Planning Commission Meeting

Date: November 1, 2021
Submitted By: Elizabeth Young Winne, Planner
Subject: Site Plan Review – Lot 2B, Block 1, Boxelder Commons

- Site Plan Review – Lot 2B, Block 1, Boxelder Commons

PAVING, & SITE
PLAN

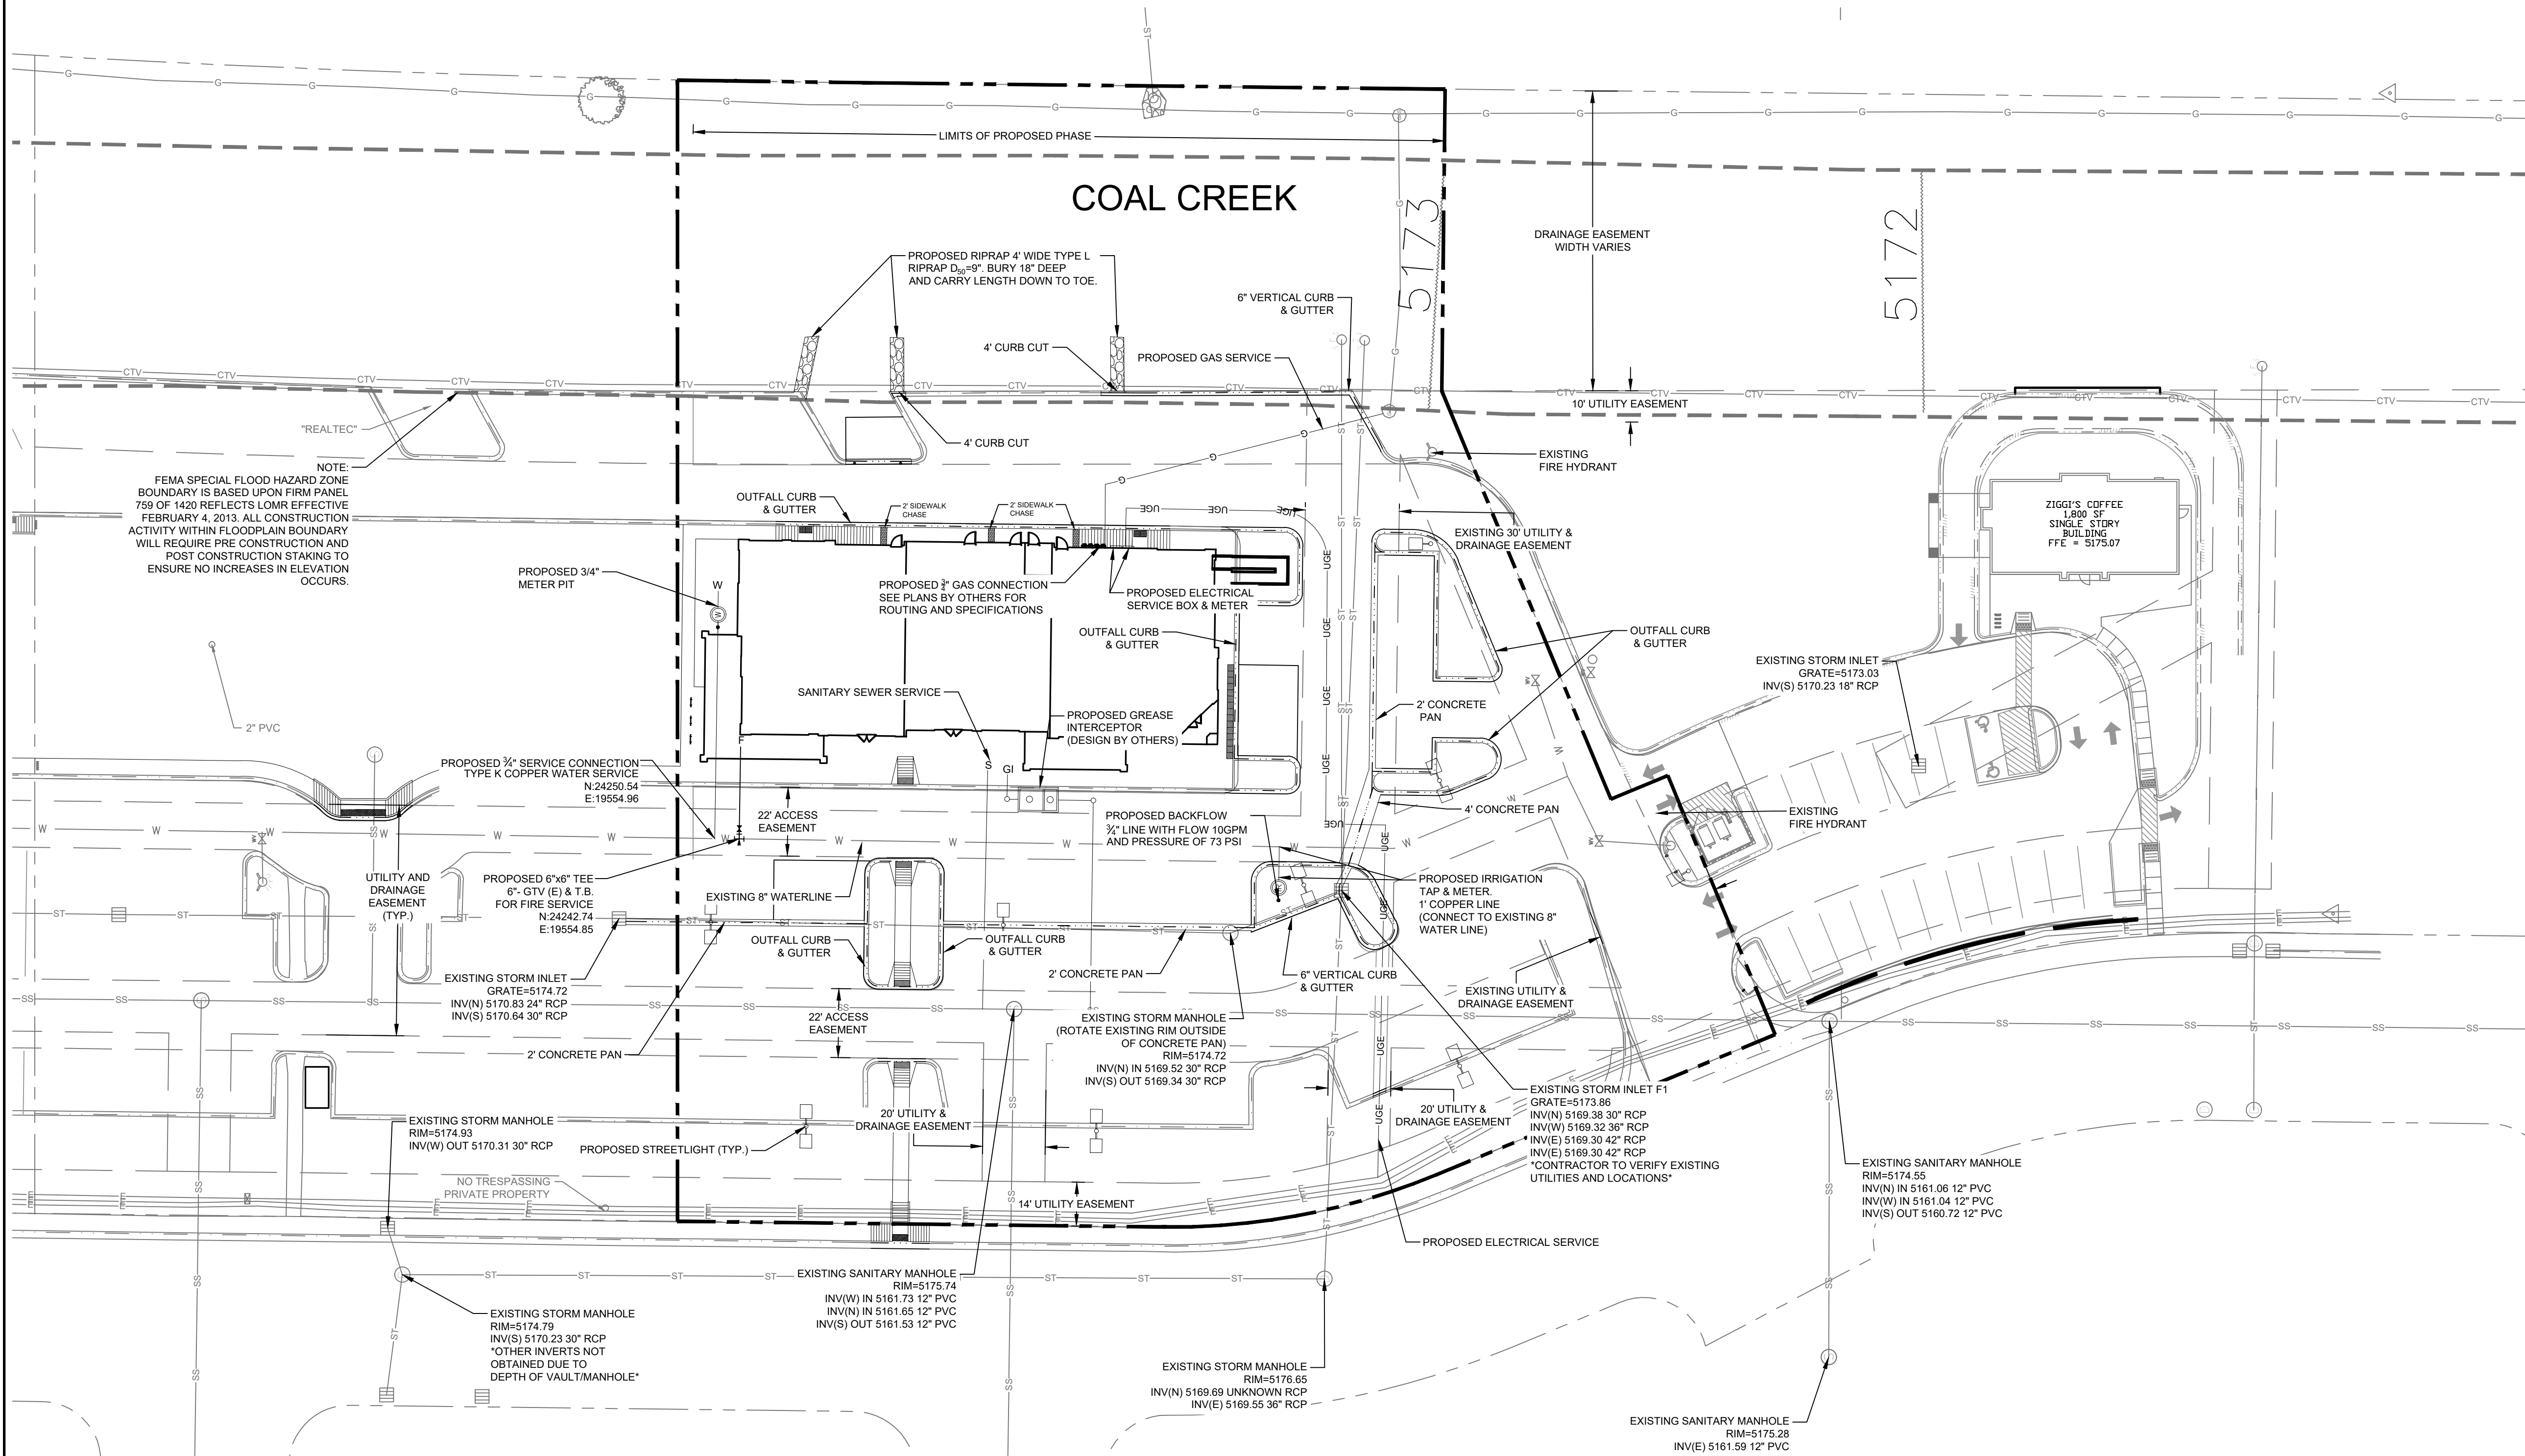
- *Size:* Parking spaces are required to comply with the minimum width and depth requirement (10 ft. x 20 ft.). The drawing shows parking spaces that comply with the dimensions. Dimension labels should be added to at least one parking space in each bank of parking spaces on the revised plans.
- *Bicycle rack info:* A bicycle rack is identified on the north side of the building (on the landscaping plan) meeting the minimum requirement. The proposed bicycle rack provides 6 bicycle parking spaces, exceeding the minimum requirement. The revised site plans should include the bicycle parking location on the "paving and site plan" sheet.

- *Details for signs:* All ADA spaces are marked as having signs. The sign height is provided on the Details sheet. Please add details for the stall sizes on the Paving and Site Plan regarding the widths of the spaces.

- On the Paving and Site Plan, the "van accessible" placard is identified. Please identify on the site plan which parking spaces are intended to be van accessible and include the van placard.

PARKING

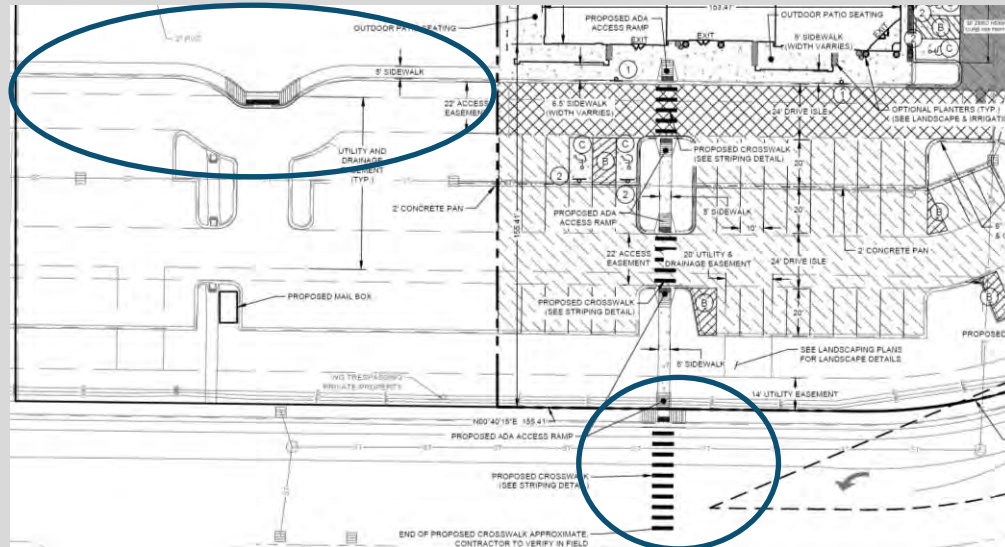
- “Current Proposal” = shows site is underparked by 23 spaces
- Applicant owns undeveloped lot between Dollar General and site
 - Parking lot on middle lot can provide 64 spaces of overflow parking for current development
- “Future Building Proposal” = for demonstration only
 - Applicant thinking about future restrictions and agreements to be made in future for viability of middle building
 - Demonstrates need for shared parking agreement with other businesses in the future

EAST AISLE

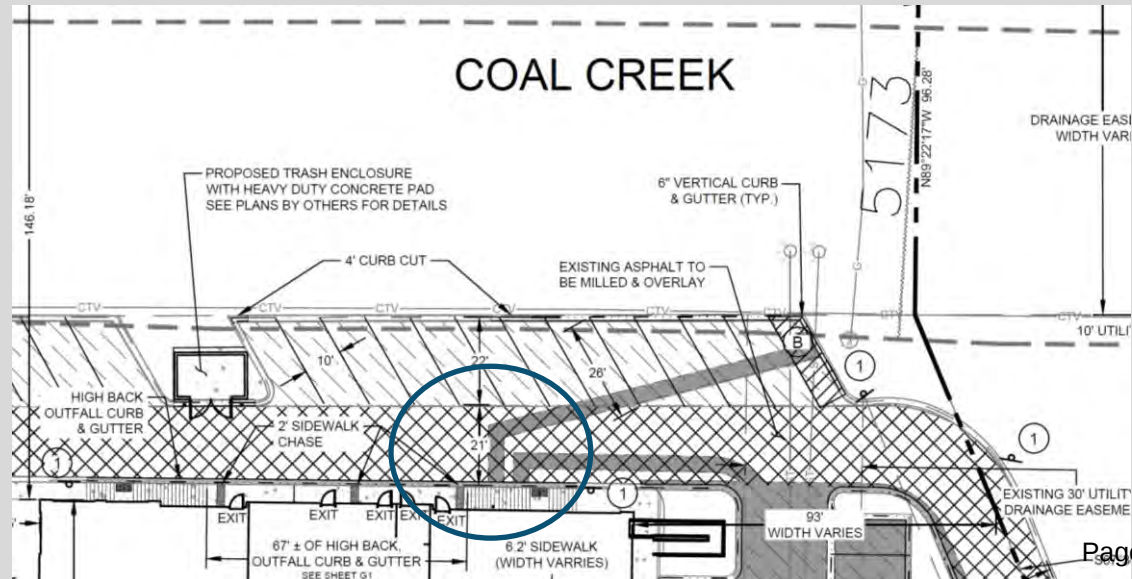
- 21'
- Already received approval for variance from WFPD's Standards
- May need one-way signage or pavement markings to be added for driver ease and understanding

LIGHTING

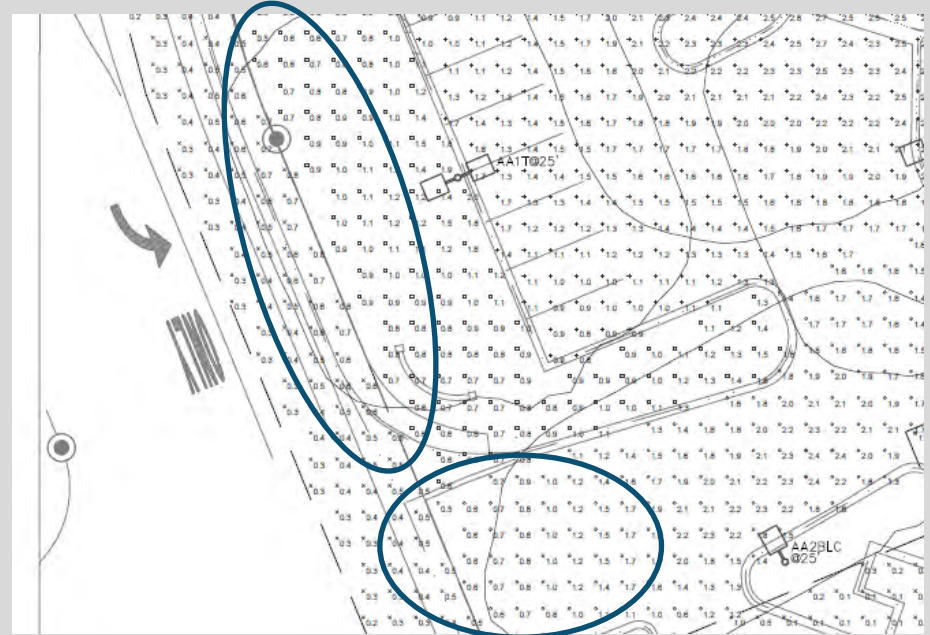
- Will there be lighting for the monument sign?
- Over maximum on west side
 - To provide for sidewalk because there are no lights on 5th
- Parking entrance below minimum
 - Reevaluate options
